**Technical Service
BULLETIN**

Title: **ACCESSORY TRAILER WIRE HARNESS**

Models:
'02 Highlander

AX002-02
ACCESSORIES

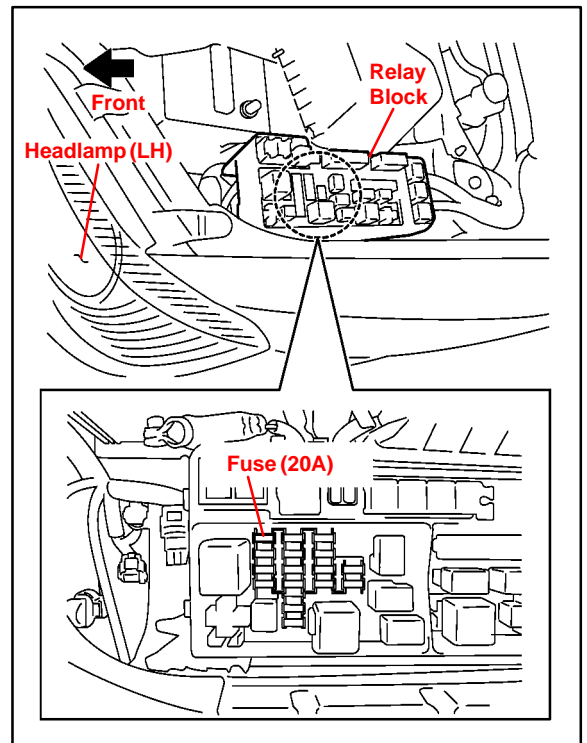
Repair Procedure Install a 20A fuse (P/N 90982-09011) into the Engine Room Relay Block as shown.
